ARCHITECT'S SUPPLEMENTAL INSTRUCTIONS

PROJECT: **Lee Lofts II, Building 2**
Historic Bldg Rehabilitation
Salina, KS

Report No. **One (1)**

Date **June 6, 2020**

DATE: 2–15–2023
JOB: 20–3120
SHEET NO.:
D2.0

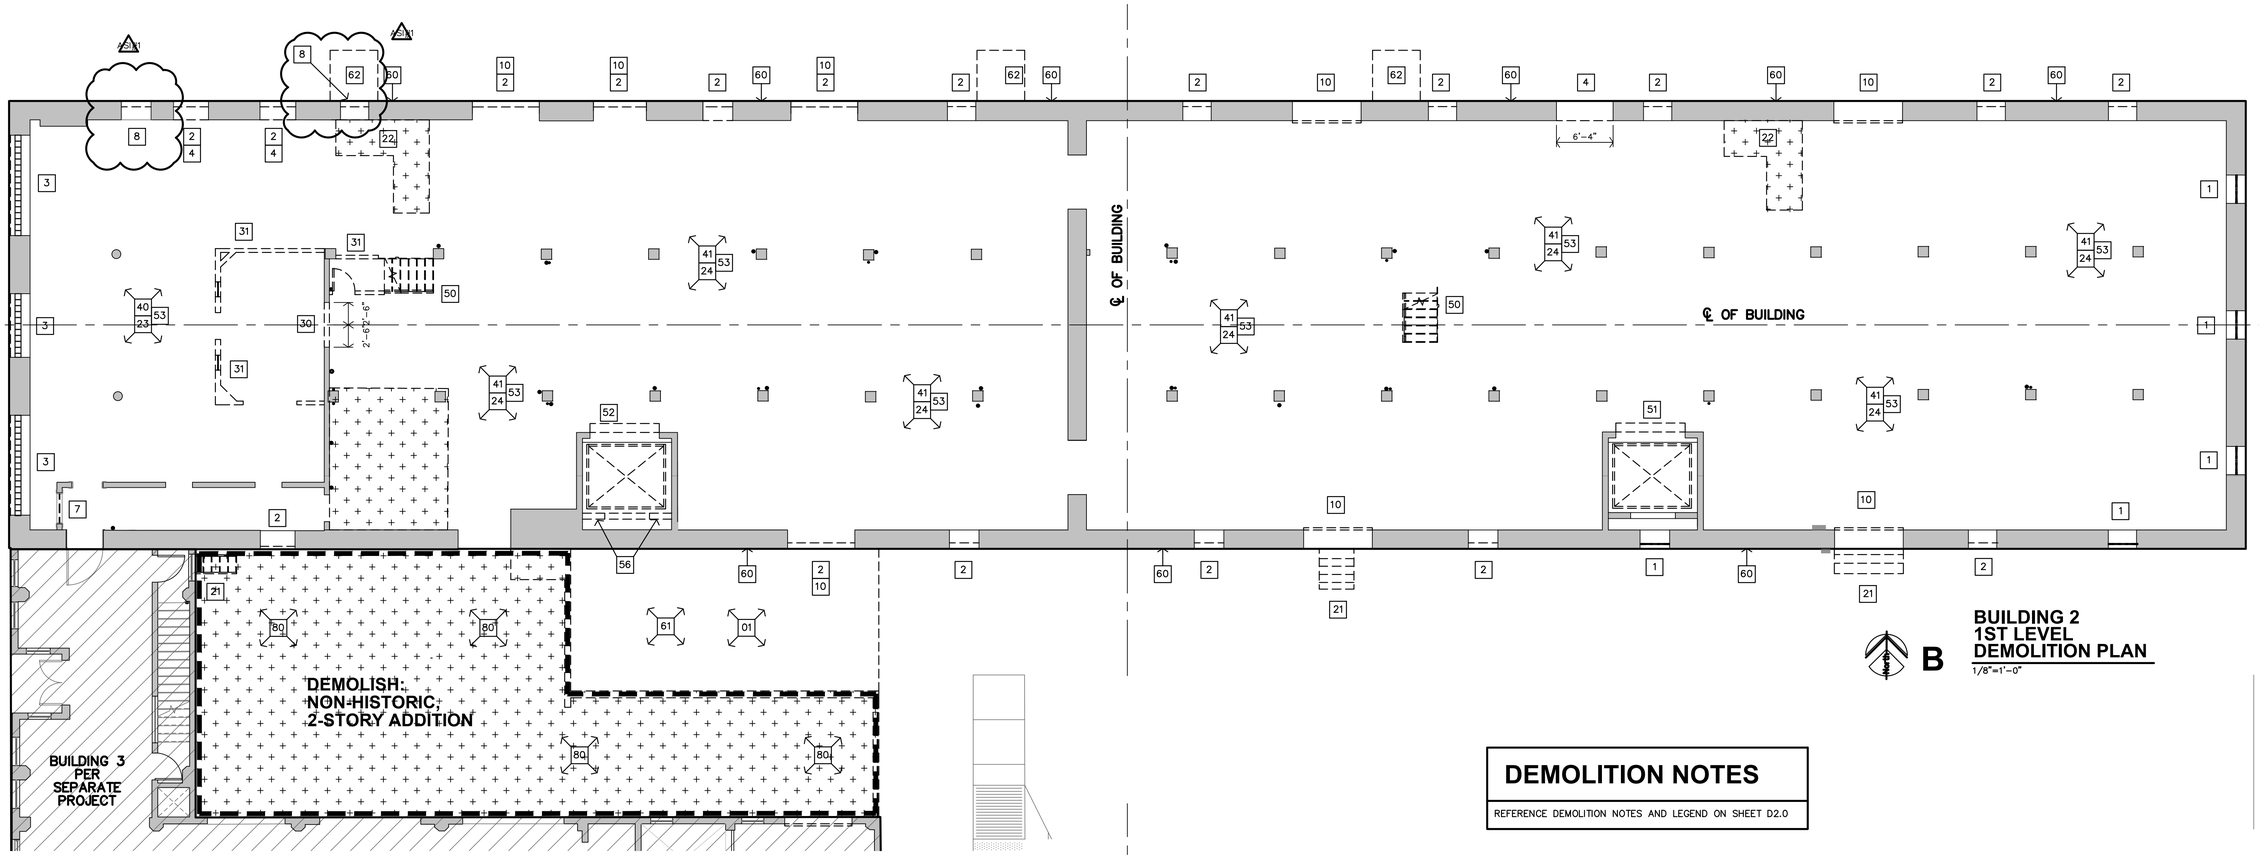
1) Contractor to make adjustments as needed and required per the modifications as indicated on attached drawings and in the below descriptions:
   a. North Elevation, at the West end, ear the existing stair: Two existing openings (currently filled with CMU) shall receive a new brick infill in lieu of a new window or CMU to remain. Brick shall match existing as closely as possible in color and texture. The west infill (at the non-historic opening) shall be flush with the exterior façade brick. The east infill (at the existing historic window opening) shall sit back 4" from the face of the adjacent brick exterior wall. Reference attached Revised Drawings D2.0, D2.1, D3.2, A2.1, A2.4 and A3.2.

ASI 1 8 REMOVE EXISTING CMU INFILL, CLEAN & PREP ORIGINAL MASONRY OPENING. TO BE IN–FILLED WITH NEW BRICK TO MATCH EXISTING.

A
BUILDING 2
1ST LEVEL - WEST END
ENLARGED FLOOR PLAN
1/4"=1'-0"

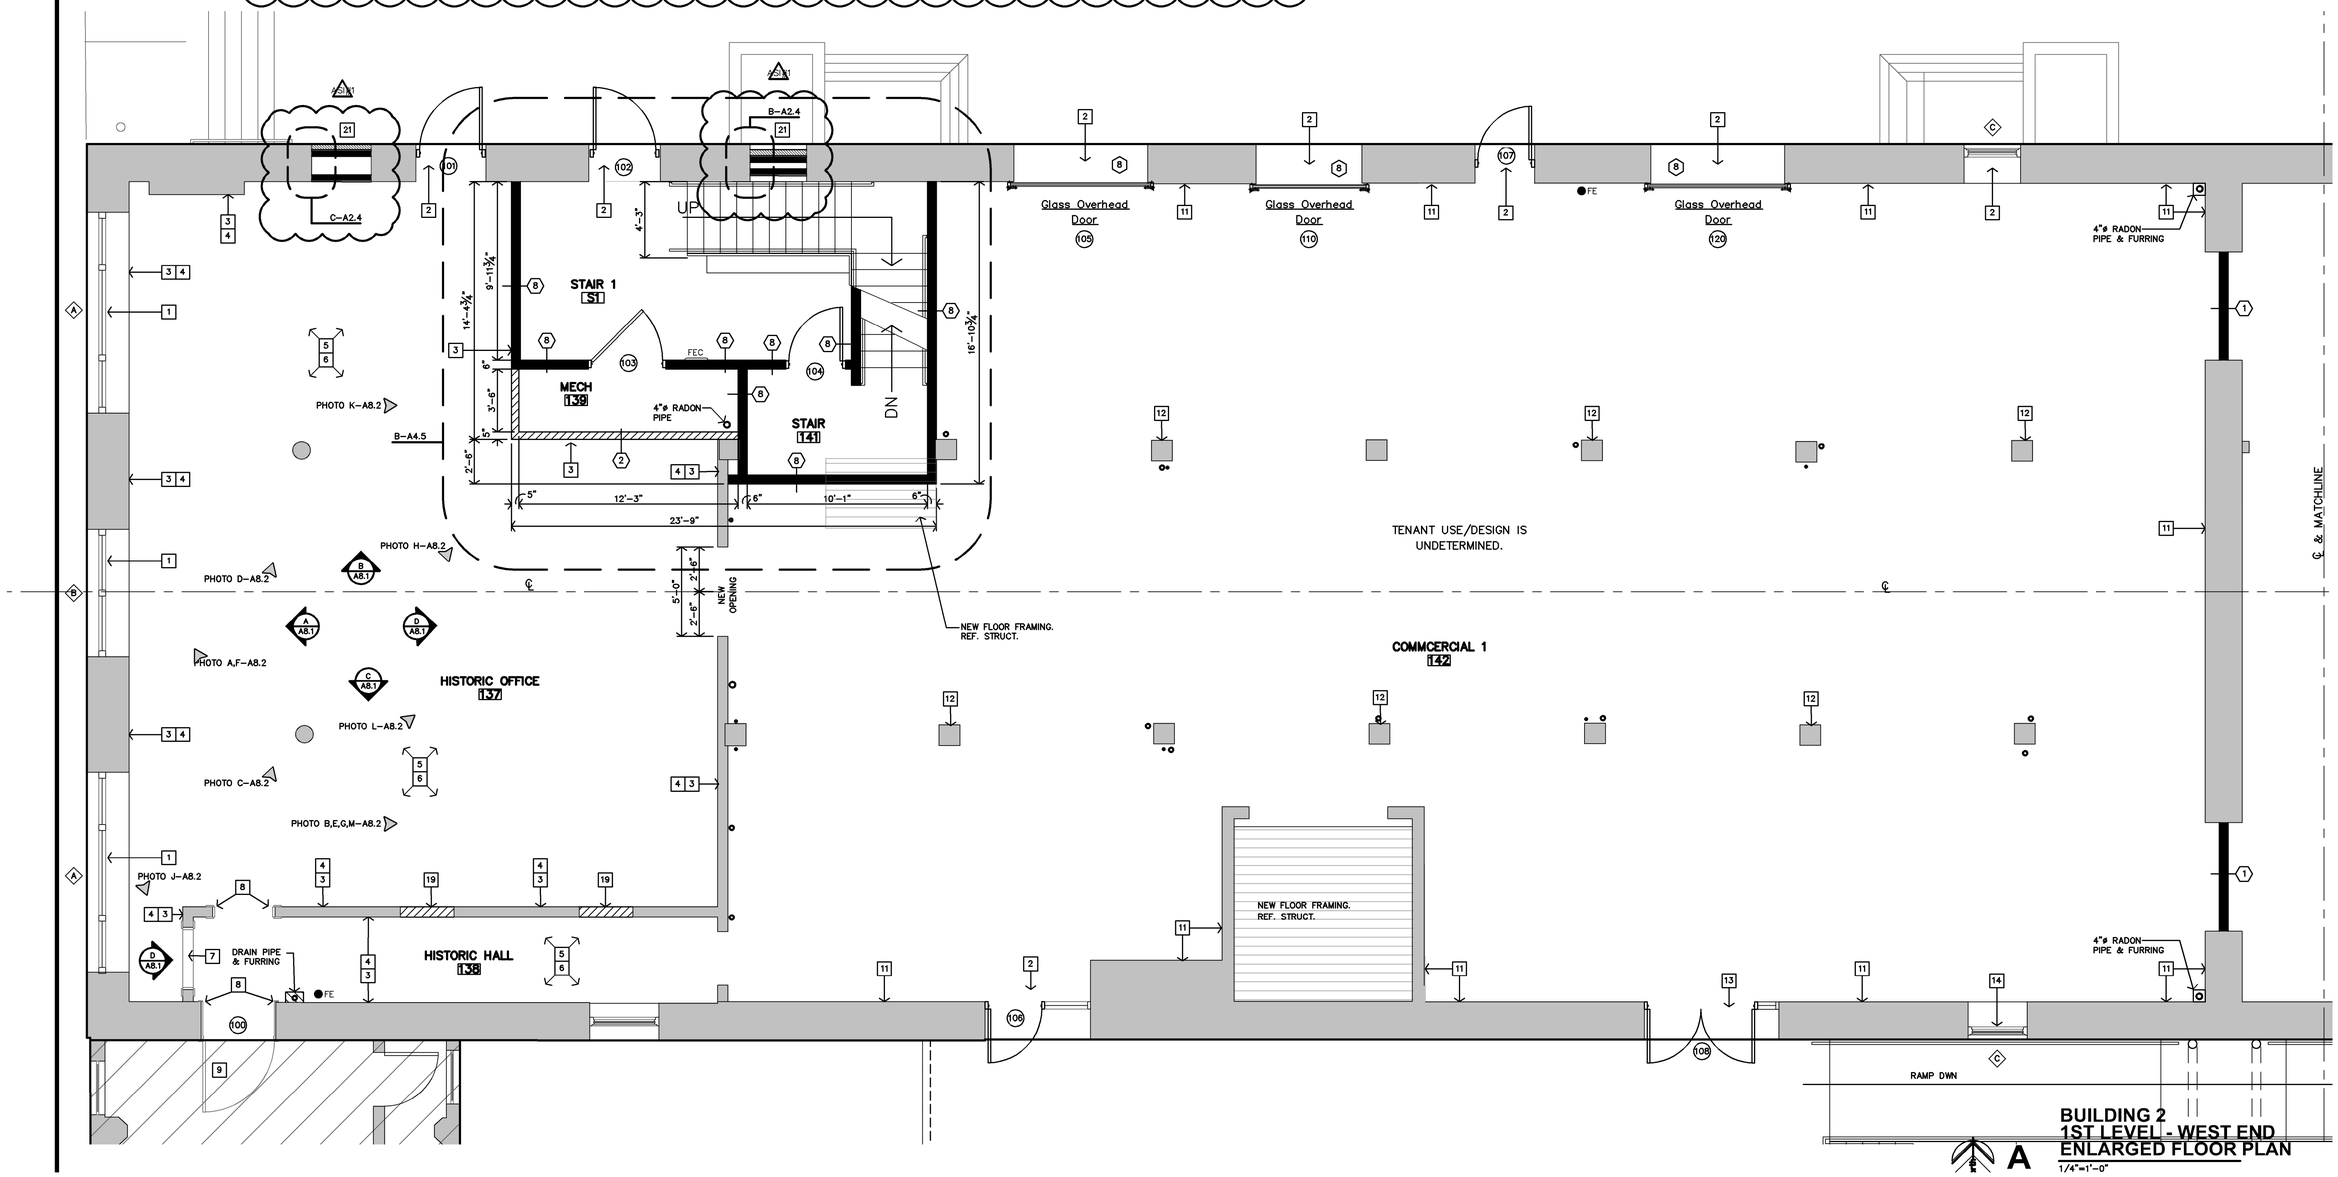
21. REMOVE EXISTING CMU INFILL AT EXISTING OPENINGS. CLEAN AND PREP ORIGINAL MASONRY OPENING. INSTALL NEW BRICK AT EXTERIOR SIDE (MATCH EXISTING BRICK IN COLOR AND TEXTURE).

A **ROOF PLAN**
1/8"=1'-0"

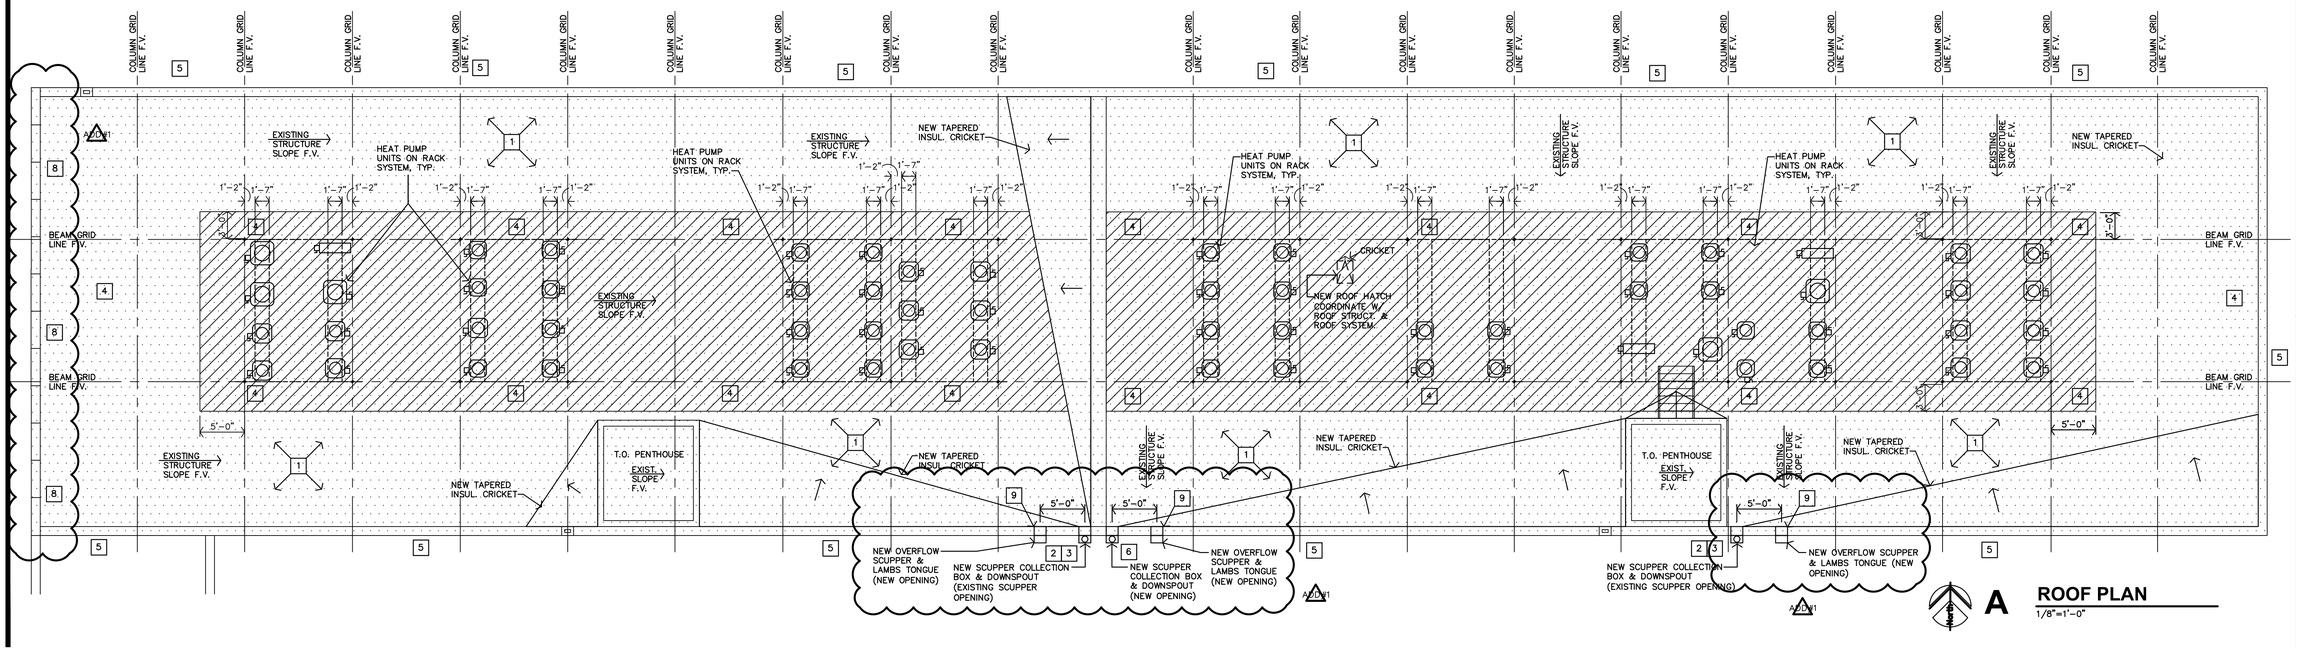
b. Roof: New metal cap over top of parapet, color shall match the existing brick as close as possible so that it blends in and does not draw attention to itself. Reference notes on revised Sheet A5.1

4. AT ALL ROOF TOP EQUIPMENT INSTALL WALK OR TRAFFIC MEMBRANE AROUND.
5. NO COPING OR FLASHING EXISTS AT TOP OF PARAPET ALONG NORTH, EAST AND SOUTH WALLS. EXISTING ROOF WRAPS OVER TOP OF EXPOSED BRICK PARAPET. INSTALL NEW METAL FLASHING CAP. METAL FLASHING COLOR SHALL MATCH THE EXISTING BRICK AS CLOSE AS POSSIBLE SO THAT IT BLENDS IN AND DOES NOT DRAW ATTENTION TO ITSELF. ADDN#1
